# NORTH ANNA POWER STATION

**NORTH ANNA POWER STATION  
IMPROVED TECHNICAL SPECIFICATION CONVERSION**

**CHAPTER 4.0 - DESIGN FEATURES**

**CHAPTER 4.0 - DESIGN FEATURES**  
**IMPROVED STANDARD TECHNICAL**  
**SPECIFICATIONS**  
**MARKUP AND JUSTIFICATION FOR DEVIATIONS**

Figure 5.1.1  
Map Defining Unrestricted  
Areas for Radioactive Gaseous  
and Liquid Effluents

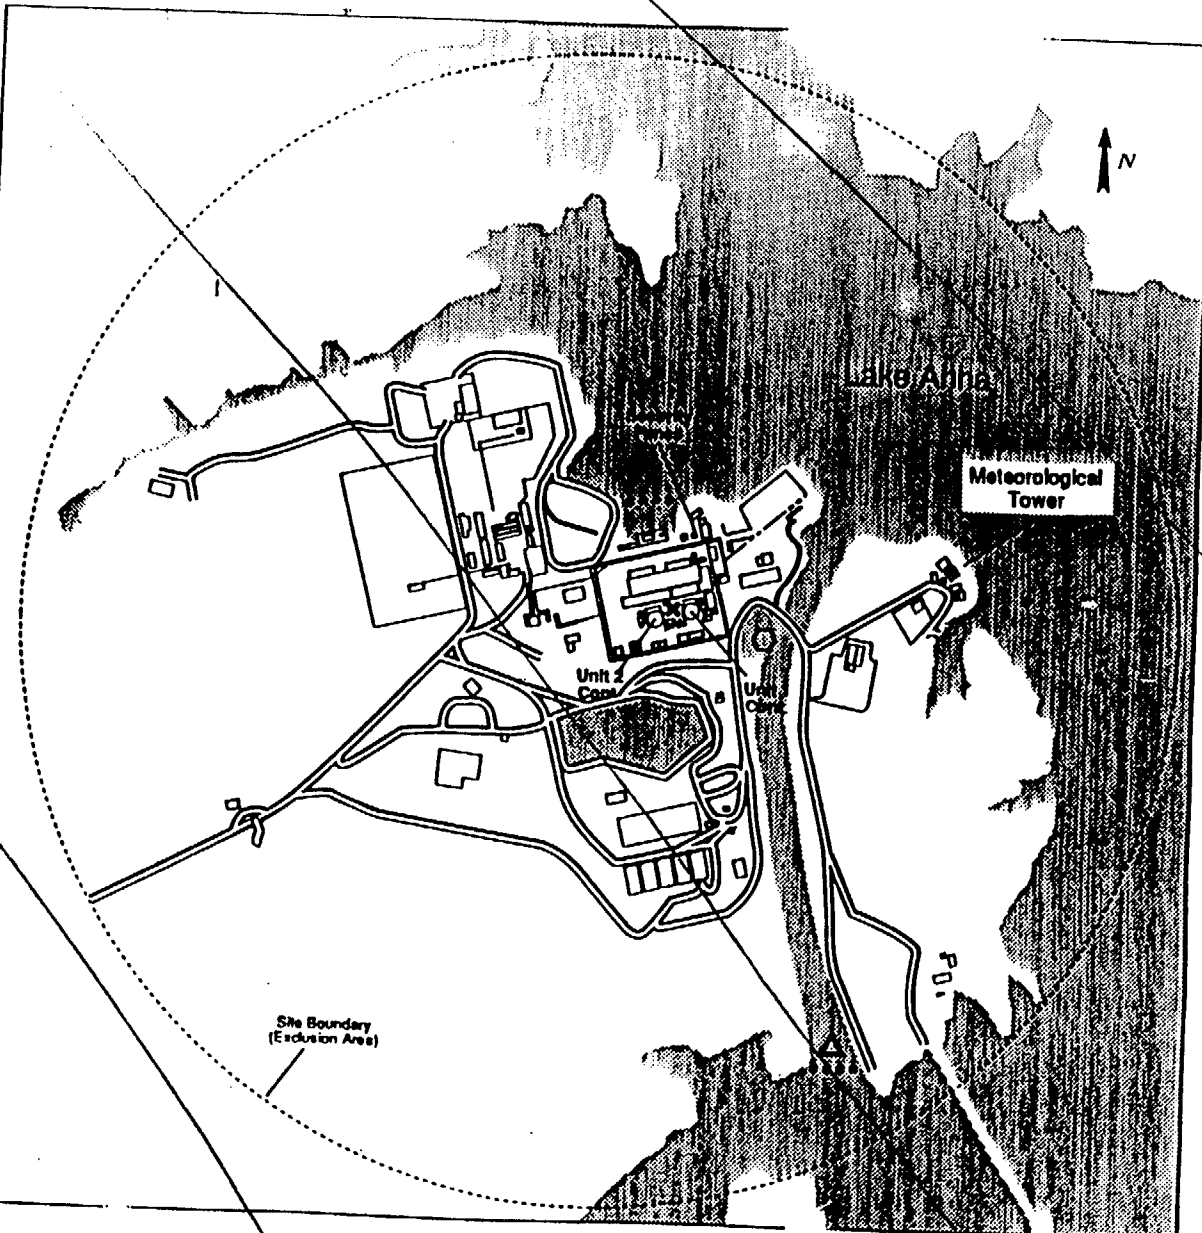
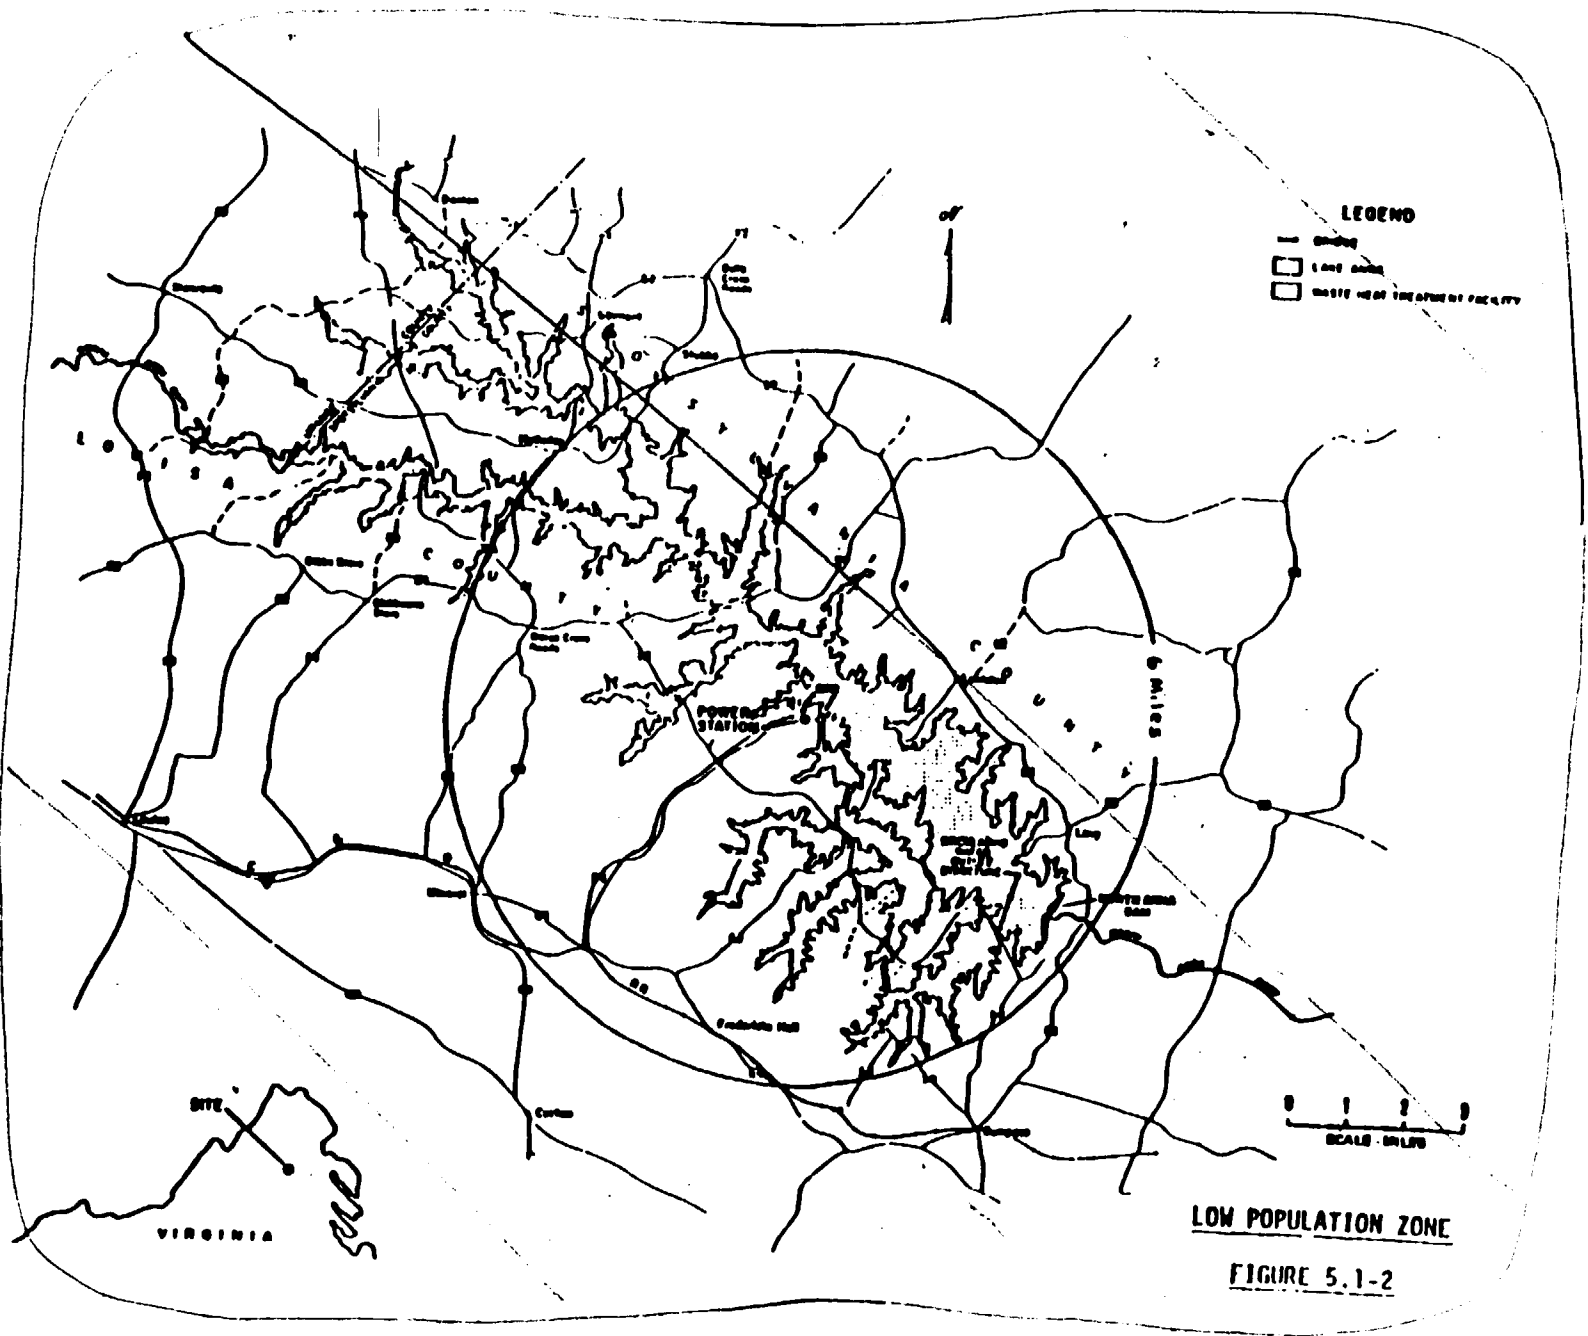
SV844C

(LA.1)

LA.1

LA.1

- LA.1 (*Type 1 – Removing Details of System Design and System Description, Including Design Limits*) CTS 5.1 contains information on the site exclusion area, the low population zone, and unrestricted areas for radioactive gaseous and liquid effluents. CTS 5.1 includes Figure 5.1.1, Map Defining Unrestricted Areas for Radioactive Gaseous and Liquid Effluents, and Figure 5.1.2, Low Population Zone. The ITS does not contain this information. This changes the CTS by removing this information.
